DEVELOPMENT APPLICATION ASSESSMENT REPORT

Application Number:	DA2023/1862
----------------------------	-------------

Responsible Officer:	Jordan Howard
Land to be developed (Address):	Lot 41 DP 13760, 214 Hudson Parade CLAREVILLE NSW 2107 Lot LIC 187249, 214 Hudson Parade CLAREVILLE NSW 2107
Proposed Development:	Alterations and additions to a boatshed, decking and skid ramp
Zoning:	C4 Environmental Living
Development Permissible:	Yes - Zone C4 Environmental Living Yes - Zone W1 Natural Waterways
Existing Use Rights:	No
Consent Authority:	Northern Beaches Council
Delegation Level:	DDP
Land and Environment Court Action:	No
Owner:	Peter Karl Heller Marianne Heller Patrick Alexander Heller Nicole Susanne Heller
Applicant:	Patrick Alexander Heller

This development application seeks consent for alterations and additions to a boatshed, decking and skid ramp.

Figure 1 - Long Section of the proposed boatshed with the portion of the roof breaching the height of buildings development standard in red.

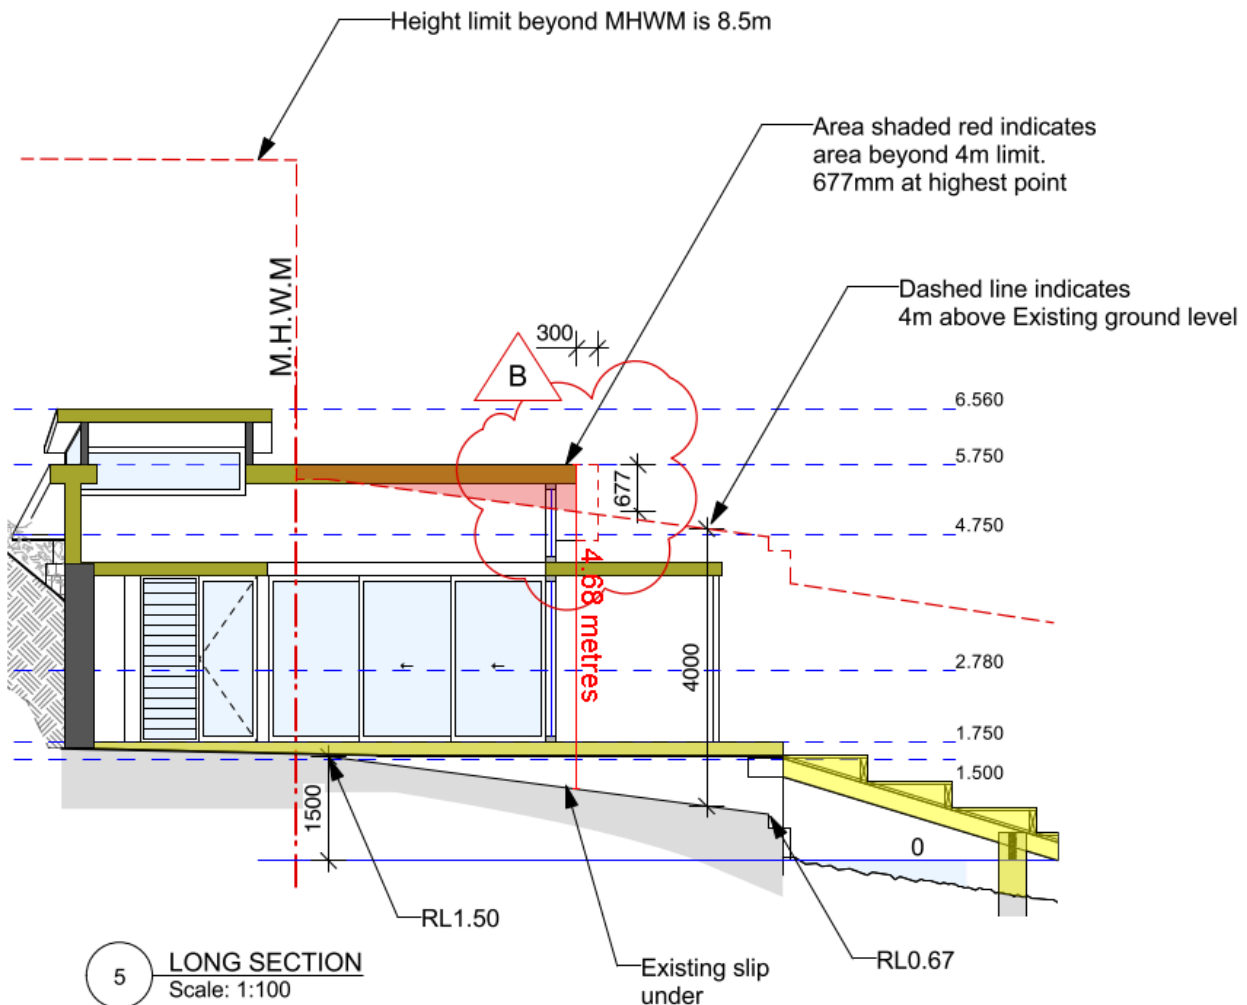
Proposed: 4.68m

Percentage of variation: 17%

The proposed boatshed is 4m in height from the platform on which it is built where below the MHWM. However, above the MHWM the proposal includes a storage platform within an elevated / pop-up section of roof, increasing the height above the platform to 4.8m. The boatshed also has a width of 4.9m and a length of 7.3m (noting that this is maintaining the footprint of the existing boatshed that is to be replaced). The pop-up roof and storage area do not form a loft or second-storey, rather it provides storage space above the Estuarine Planning Level.

Council is satisfied that the Applicant has demonstrated that there are sufficient environmental planning grounds to justify the contravention of Clause 4.3 Height of buildings for the following reasons:

Council is satisfied that the Applicant's written request under Clause 4.6 of the Pittwater Local Environment Plan 2014 seeking to justify variation of the development standard contained within Clause 4.3 Height of Buildings has adequately addressed and demonstrated that:

- Compliance with the development standard is unreasonable or unnecessary in the circumstances of the case; and
- There are sufficient environmental planning grounds to justify the variation.
